NHTSA Safety Recall 23V-694

SUBJECT: Campaign # 179 – View, Navion, and Era Awning Deployment

View/Navion Awning Rework: Recall #179 Work Instruction Addendum

Era Awning Rework: Recall #179 Work Instruction Addendum

Image 1

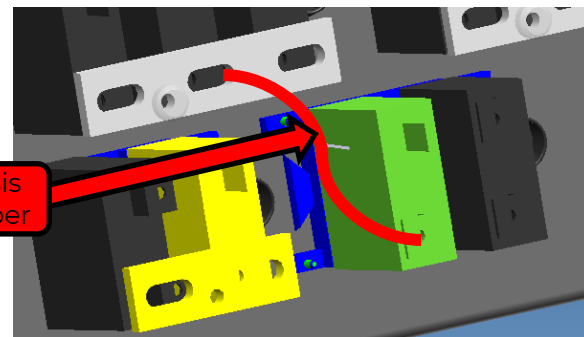
1. In step 1 of the existing instructions, it states to disconnect the chassis battery, see Image 1. When disconnecting the chassis battery, follow the note below:

- a. **NOTE:** If the chassis battery ground is not disconnected five minutes or more before disconnecting any connectors from the seats, chassis faults may occur that will require a Mercedes service center to clear. This cost is not covered under this recall.

Wiring Diagram – General

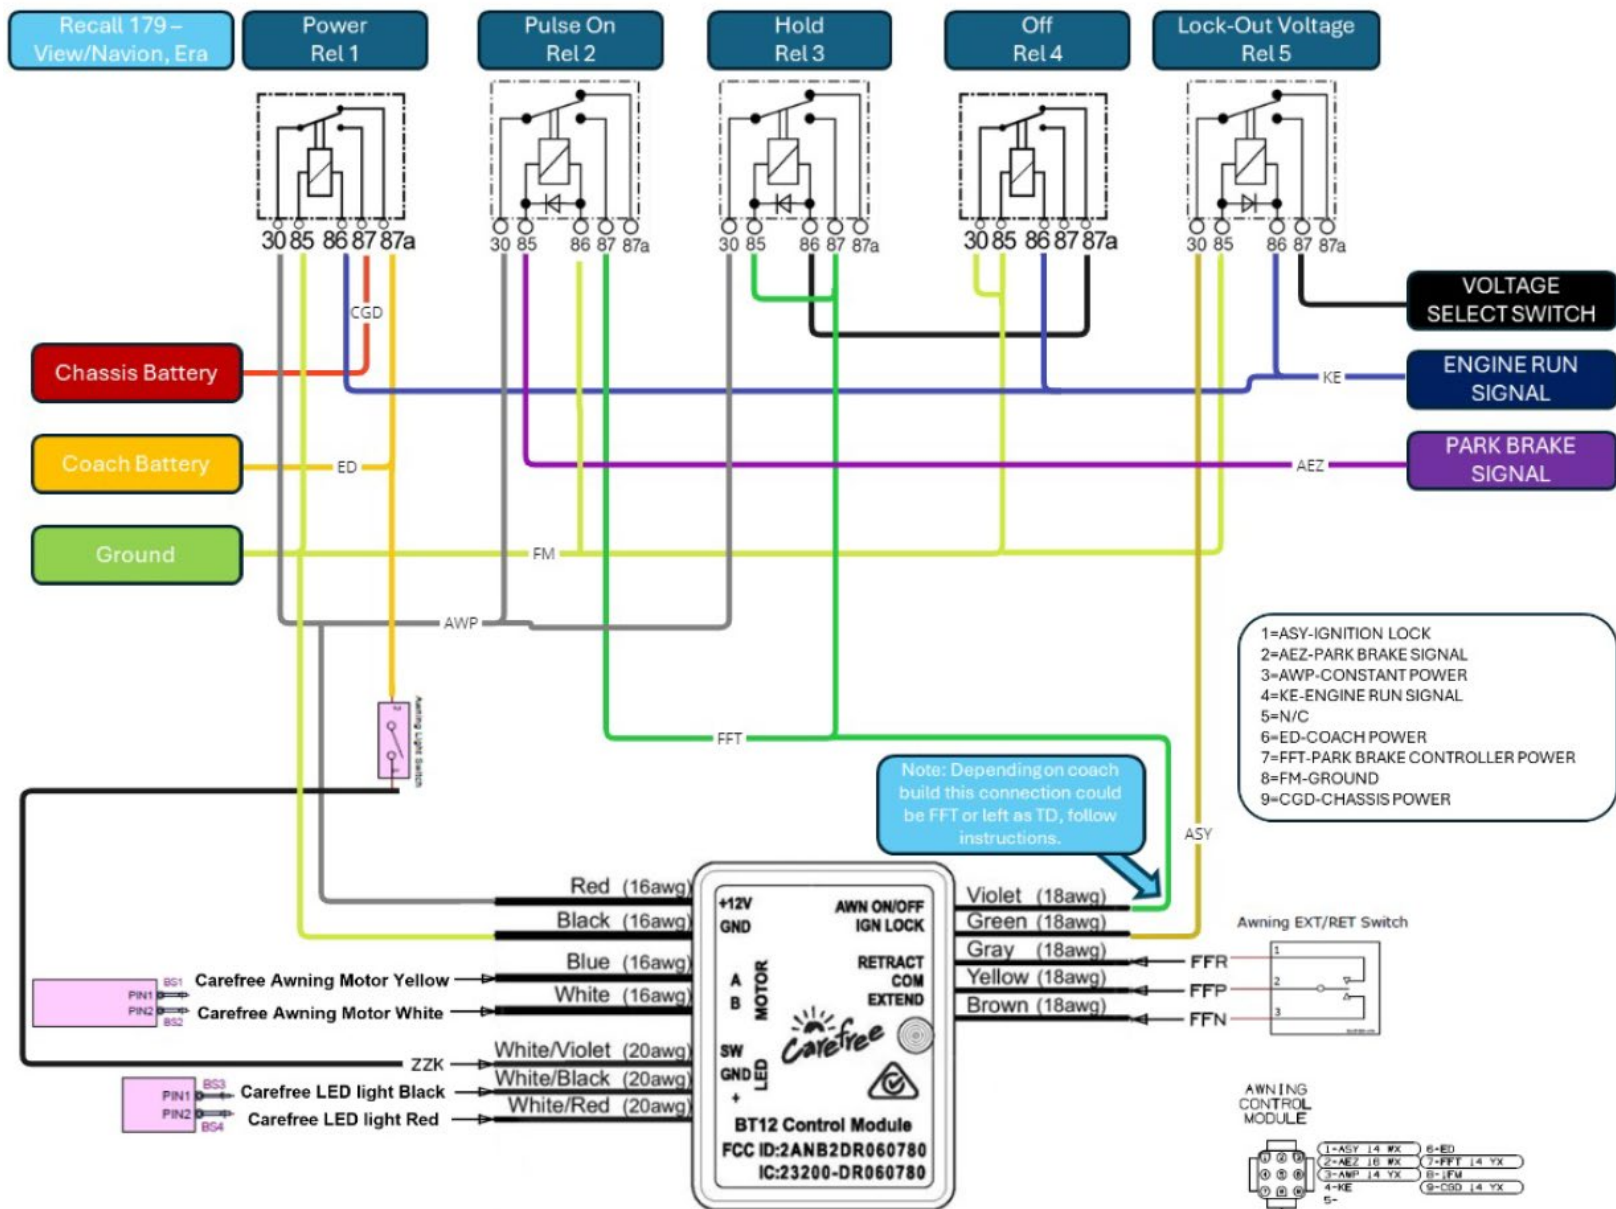
5. All other steps in the existing packet should be followed.
6. At the end of this packet is a general wire diagram for Recall 179, use this to aid troubleshooting as needed.

Image 5

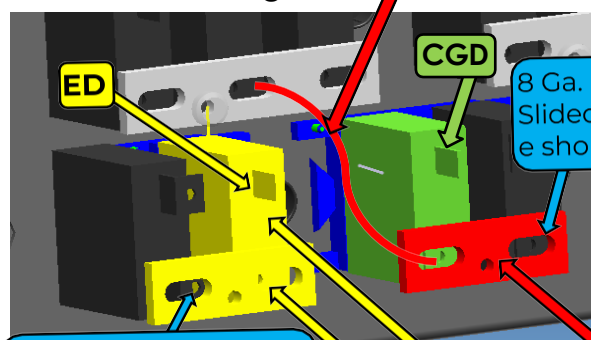
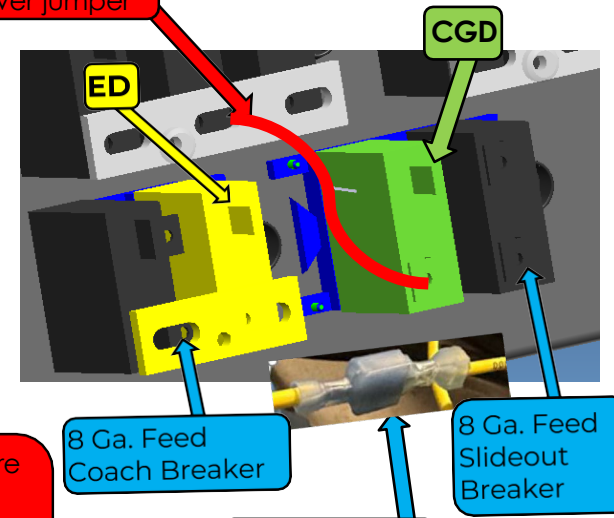
Add Chassis power jumper as required. Units built before October 24, 2022 did not include this cable.

If the 30A slideout and 15A awning breakers are connected by a buss bar, **remove and discard Buss bar**. Add chassis power jumper from triple buss bar above to lower "Chassis awning" breaker connection and connect the original 8 Ga feed cable to the 30 A slideout breaker.

Step 5 – Connect new awning circuits in passenger's seat pedestal.

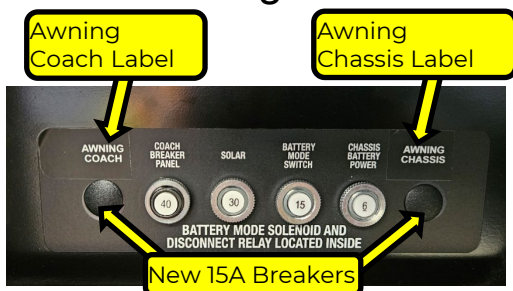
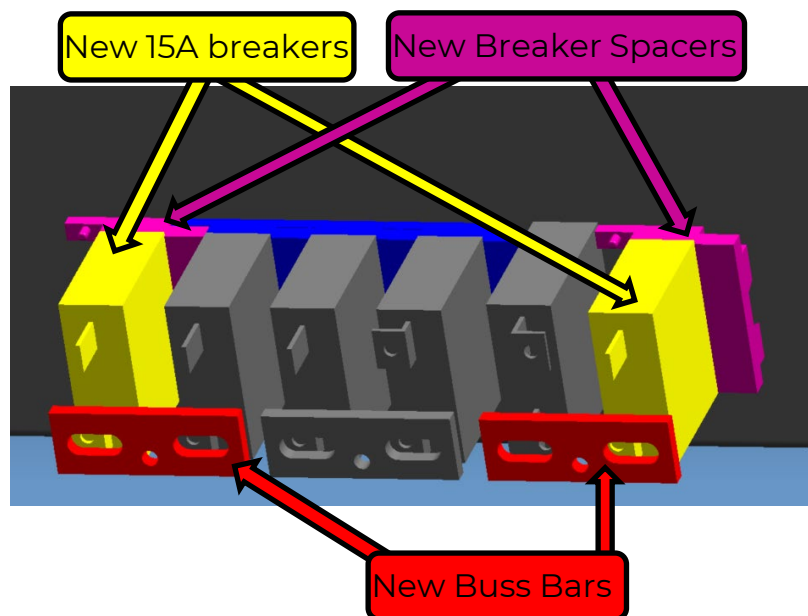
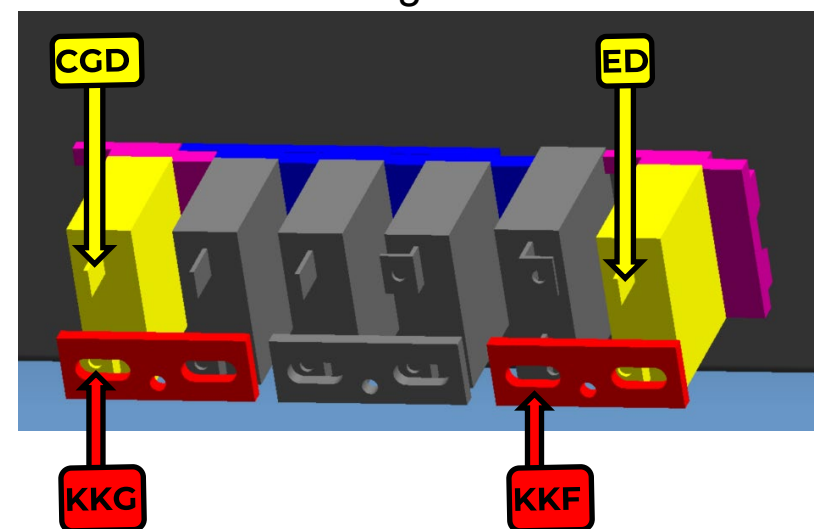
2. For “Step 5 - Connect new awning circuits in passenger's seat pedestal.”, disregard the existing packet instructions and follow the instructions for Step 5 in this packet.

1. Locate the Winnebago 12v breaker panel under passenger's seat and remove the plugs from the "Slideout" and "Radio" positions – see Image 1.
2. Add in the supplied 15 Amp breakers with spacers(for alignment) into both open positions.

3. Cut "Awning Chassis" and "Awning Coach" out of the supplied label 358911-01-000. Install these sections over the existing label as shown in Image 1.

4. Remove circuits KKF "Yellow Feed" and KKG "Purple Feed" from the existing breakers.
5. Install a buss bar between the breakers labeled "Awning coach" and "Coach Breaker Panel". Connect KKF "Yellow Feed" to the bus bar.

6. Install a buss bar between the breakers labeled "Chassis Battery Power" and Awning Chassis". Connect KKG "Purple Feed" to the bus bar.
7. Connect new circuit ED to the top connector on the 15a breaker "Awning Coach", Connect new circuit CGD to the top connector on the 15 Amp breaker "Awning Chassis".

8. FFT on the new harness will not be used. Use electrical tape to cover the connector.
9. Note: Depending on coach build, the "Chassis Battery Power" breaker will either be 6 Amp or 15 Amp. This will not affect the recall.

10. Tape up the male spade terminal on circuit FFT in the new harness, it will not be used.

Wiring Diagram – General

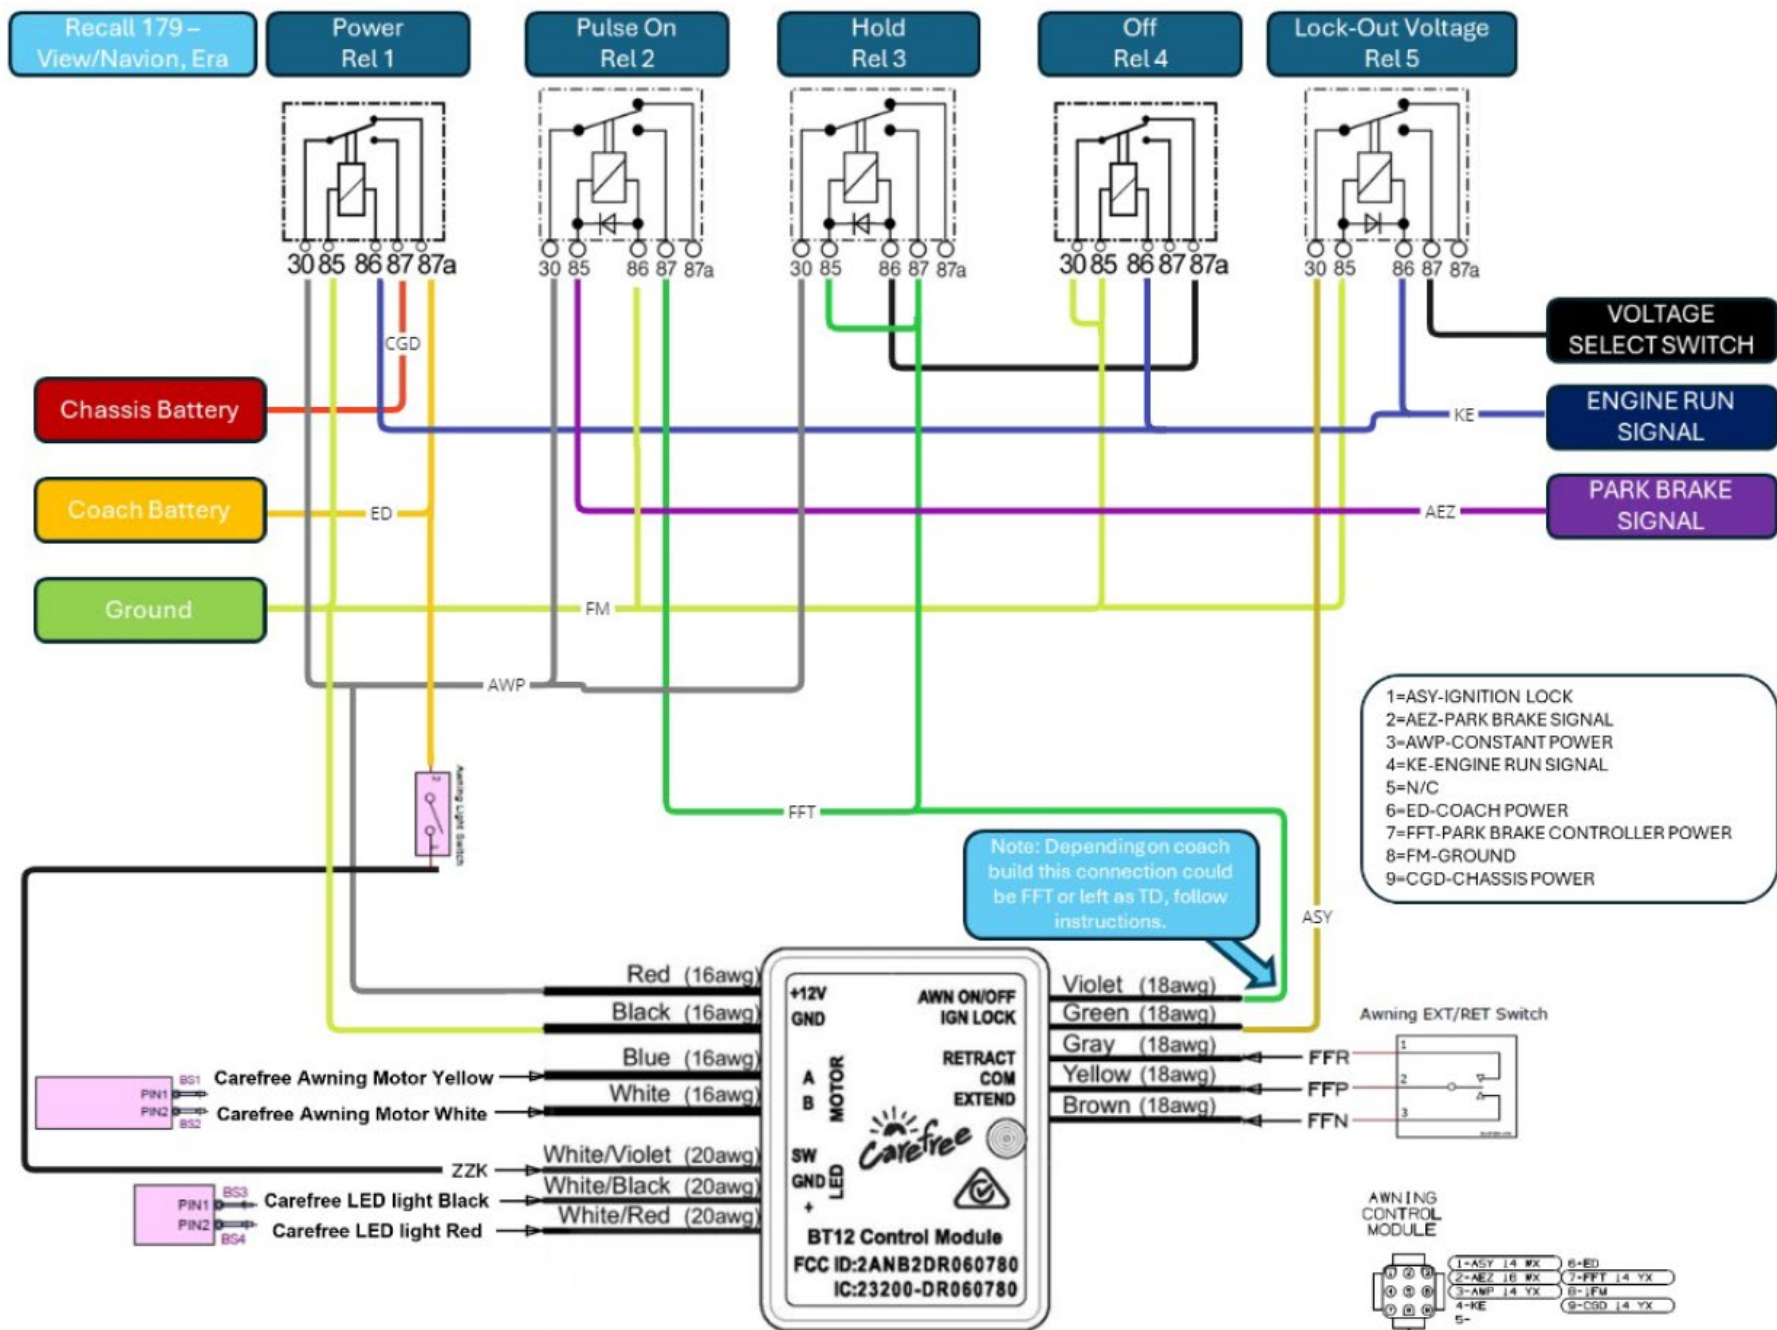
5. All other steps in the existing packet should be followed.
6. At the end of this packet is a general wire diagram for Recall 179, use this to aid troubleshooting as needed.
